TN302_941 Layout Review

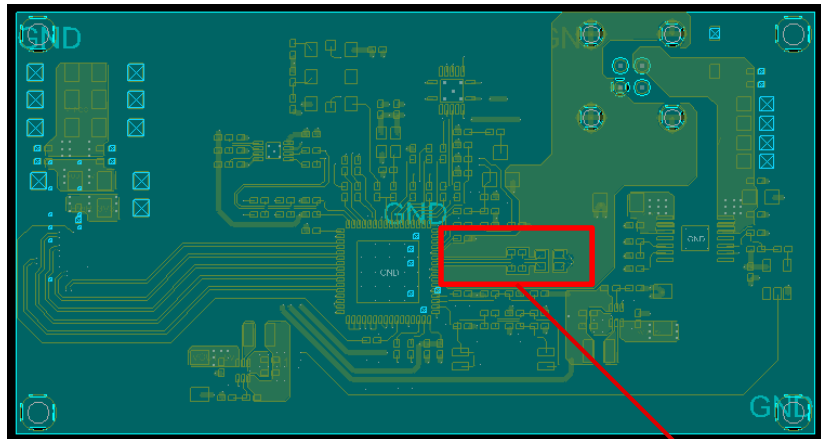
FPD-Link III Signal Trace Dout0+/-
Recommend keeping intra-pair length mismatch
to <5 mils if possible

FPD-Link III Signal Trace Dout0+/- AC Cap

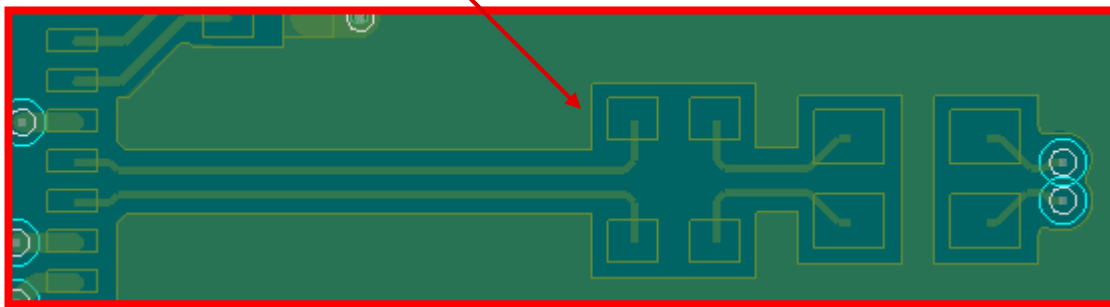
An impedance mismatch can occur with the addition of the component landing pads. We recommend doing impedance calculation to ensure the 100 Ohm differential impedance along the trace. Relief cuts to the below GND layer can help with impedance control.

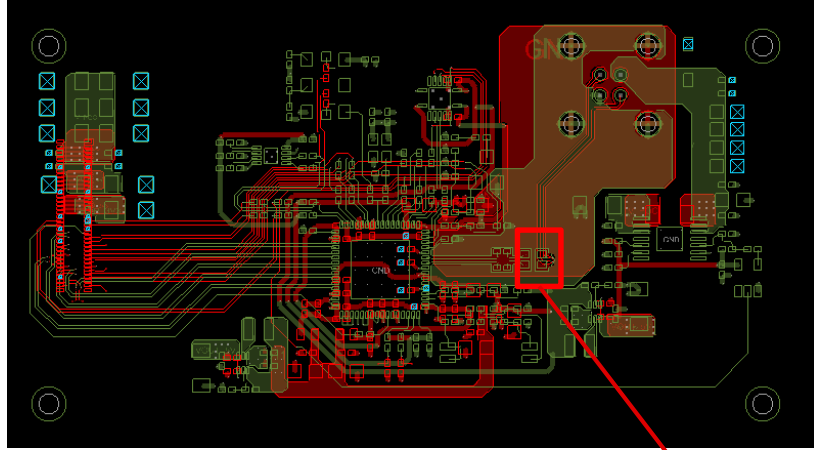
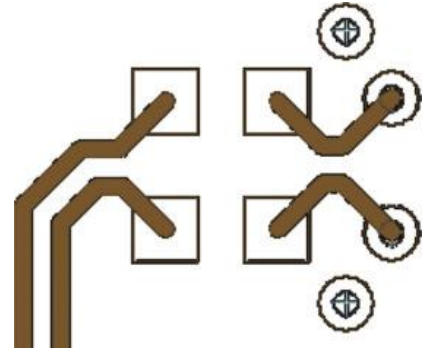
Recommend adding differential vias for impedance continuity across layers

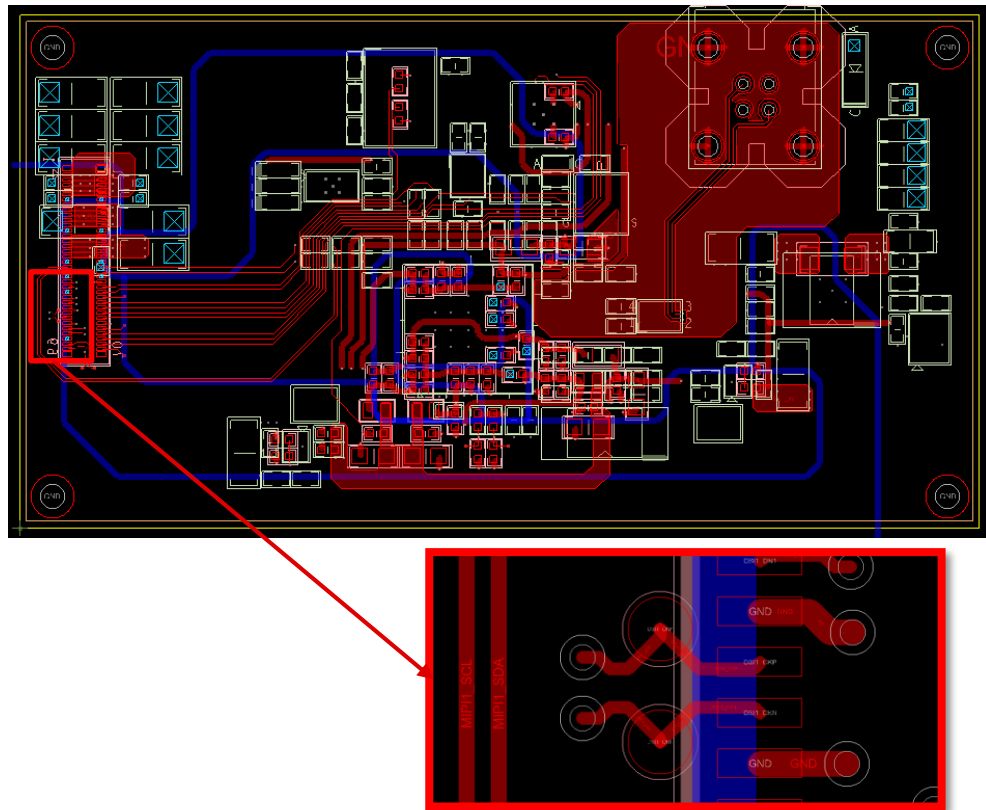
Keep the use of bends in differential traces to a minimum. When bends are used, the number of left and right bends must be as equal as possible, and the angle of the bend should be ≥ 135 degrees.
